PRODUCT/PROCESS CHANGE NOTICE (PCN)

ATTACHMENT I - PCN #: TB0812-03

PCN Type: Packing Material

Detail of Change: This notification is to advise our customers that IDT has qualified new shipping trays for 15 mm x 15 mm CABGA-196 & 15 mm x 15 mm CABGA-208.

Existing Shipping Tray

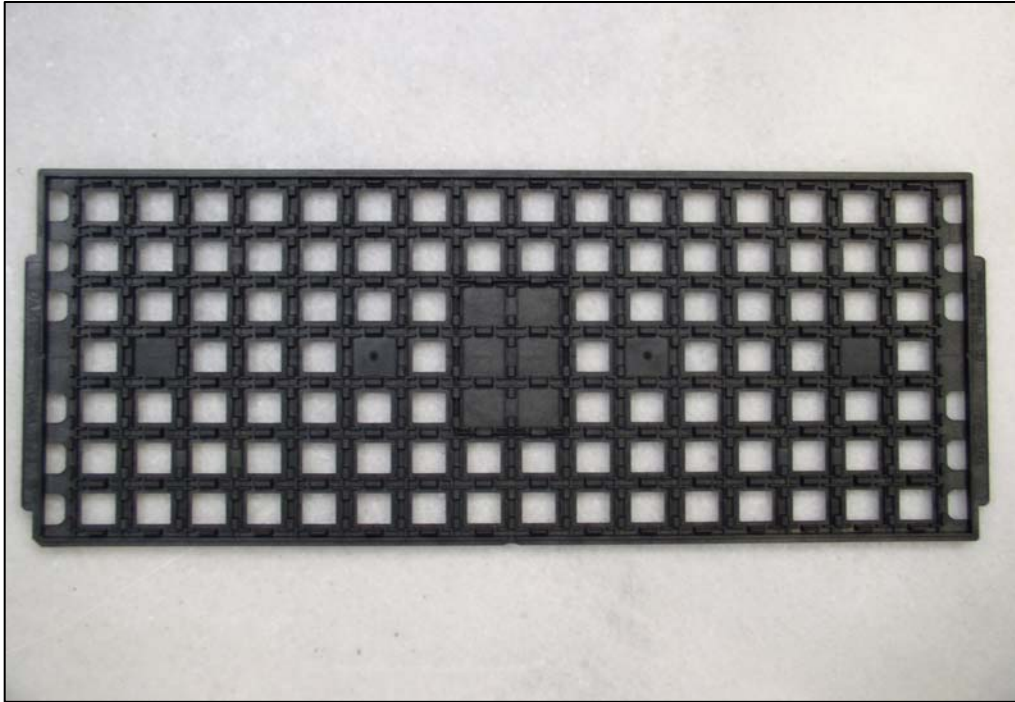
There will be changes in number of units per tray from 112 to 126 and changes in the tray dimensions.

New Shipping Tray

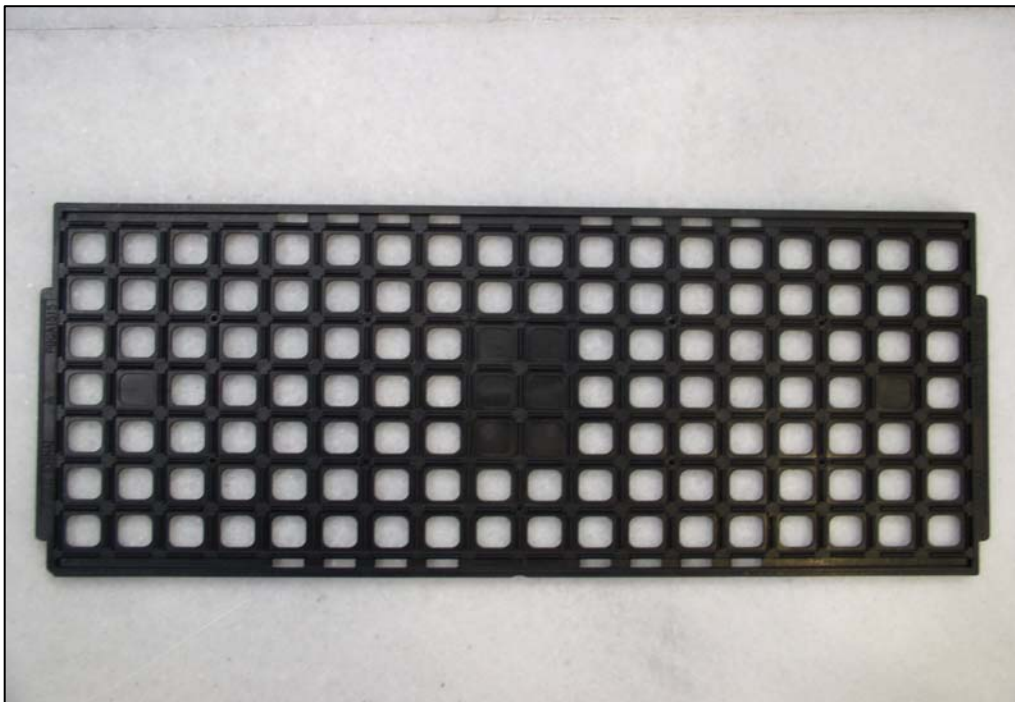
The new shipping trays have passed IDT's internal qualification requirements.

| TITLE: | BF/BFG 289 | DRAWING NO. | MSC-5801 |

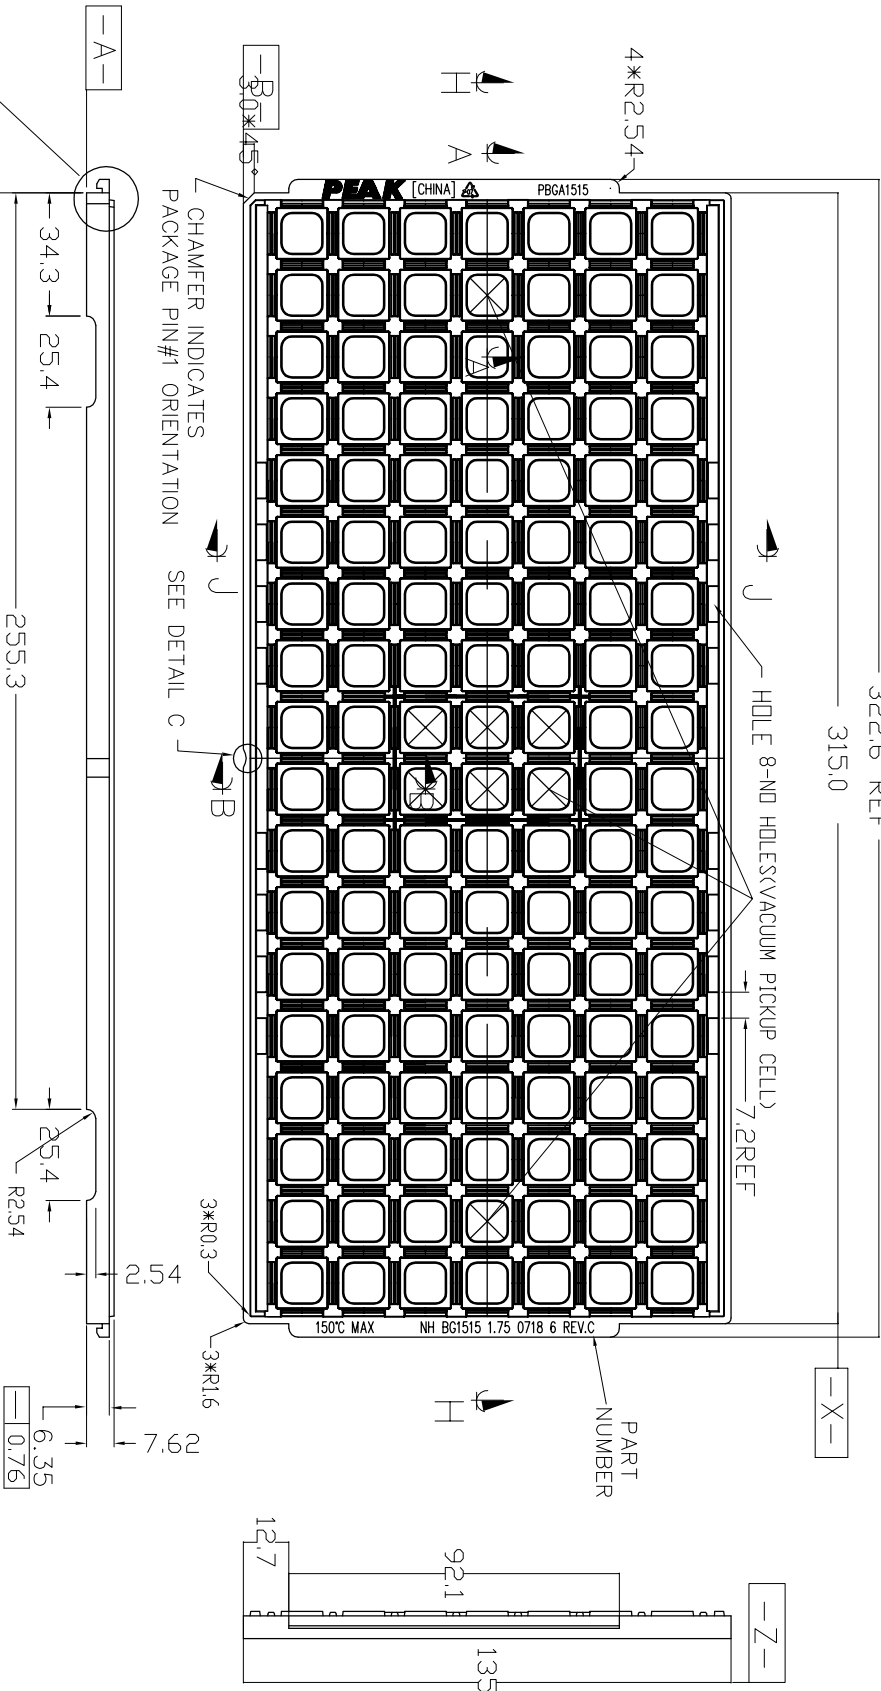
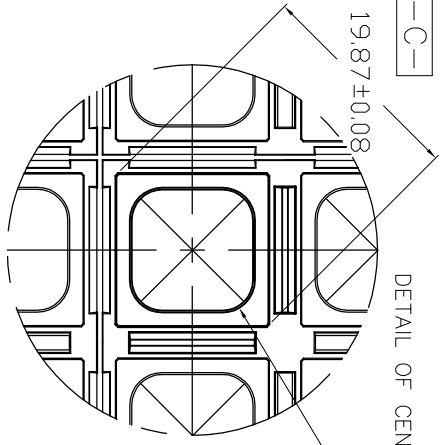
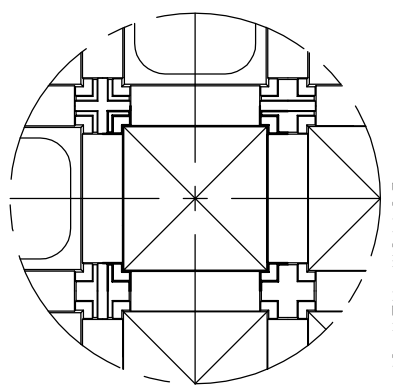
| Description | Existing Shipping Tray | New Shipping Tray |
|----------------------|---------------------------|-----------------------------|
| Tray Drawing Number | MSC-1707 | MSC-5801 |
